## Department of Transportation

#### MEMORANDUM

**SUBJECT:** ZC Case No. 20-09 – 2419 25<sup>th</sup> Street SE

**Figure 2 | Impacts to Site if 30-Foot Berth Zoning Requirement Met**

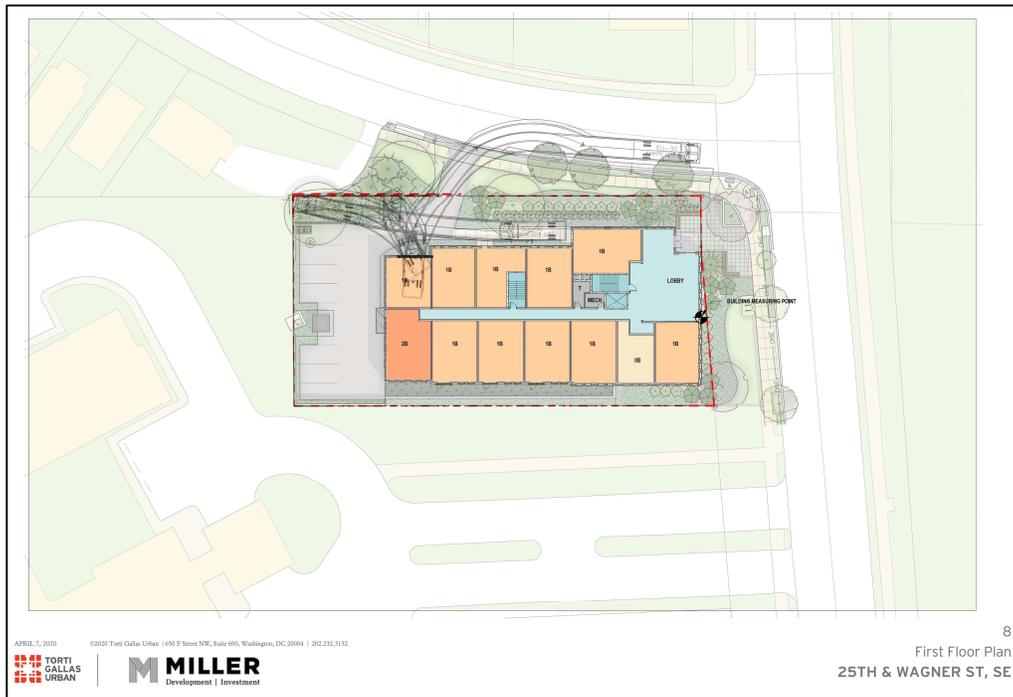
The site design allows for truck deliveries to take place in the service/delivery space at the northern end of the surface parking lot. The truck turning diagrams included in the August 10, 2020 Transportation Statement demonstrate that 20-foot trucks can enter and exit the service/delivery space with head-in and head-out movements. The site design, however, provides significant constraints for a 30-foot truck, as shown by Figure 2 below. If the Applicant were to provide a 30-foot loading berth and platform as required by ZR16, the proposed development would lose approximately five (5) affordable senior housing units to provide adequate space for the truck turning maneuvers and would require additional pavement resulting in a loss of green space, trees, and landscaping. The truck maneuverings below also show impacts beyond the extents of the property line and would require a wider curb cut than DDOT would support for the scale of the development project.

Given the proposed senior housing use, the size and mix of units, and the negative impacts to site design, staff supports the proposed relief from the 30-foot loading berth and platform and believes that the proposed service/delivery space will be able to accommodate move-ins/move-outs. As for trash, the trash room is in the cellar/basement of the building and will be rolled down the driveway for pickup on Wagner Street.

**Figure 4 | Existing Pedestrian Network**

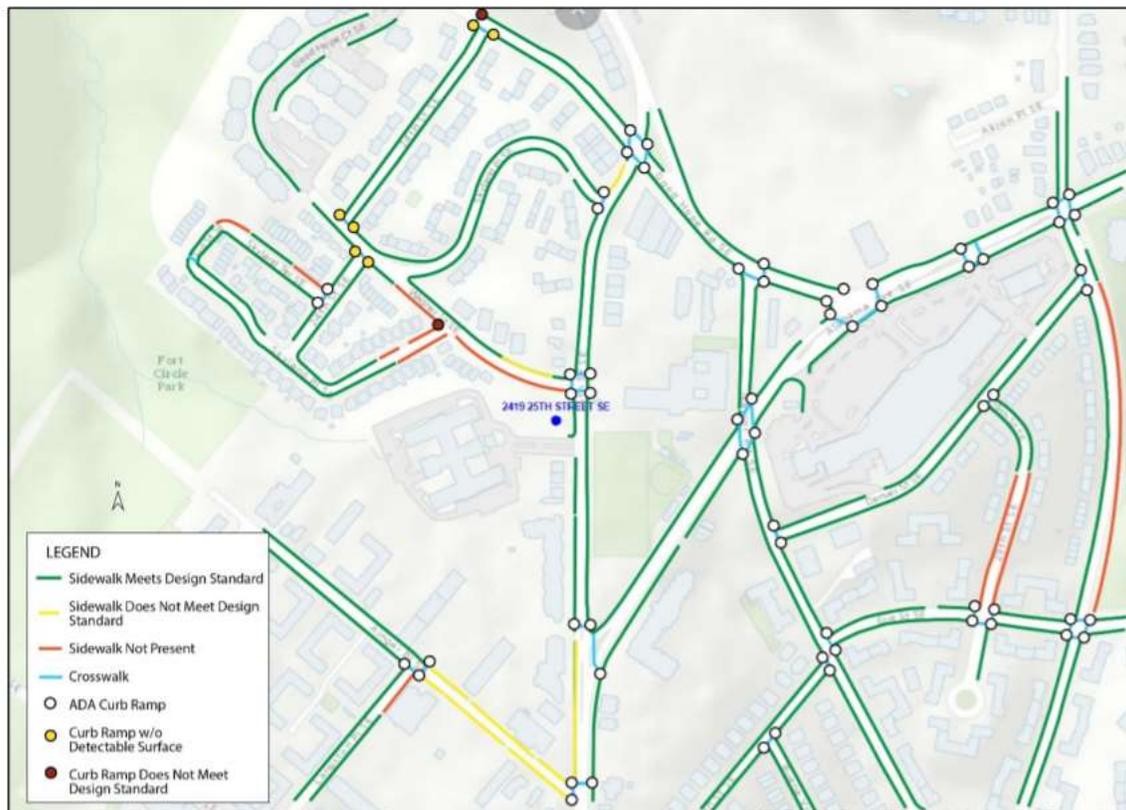
The Applicant’s inventory of existing pedestrian infrastructure, as shown in Figure 4 below, demonstrates that most sidewalks in the immediate vicinity of the site are currently constructed with appropriate widths and include accessible curb ramps, excluding Wagner Street which is directly adjacent to the subject site.

To increase pedestrian connectivity and safety in this area, the Applicant has agreed to fund and construct a DDOT-standard sidewalk on Wagner Street SE from 25<sup>th</sup> Street SE to the adjacent single-family property directly west of the subject site, as well as a curb extension on Wagner Street SE at the intersection of 25<sup>th</sup> Street SE. The curb extension will make the stop signs more visible to drivers, shorten the crossing distance for pedestrians, and slow turning vehicles.
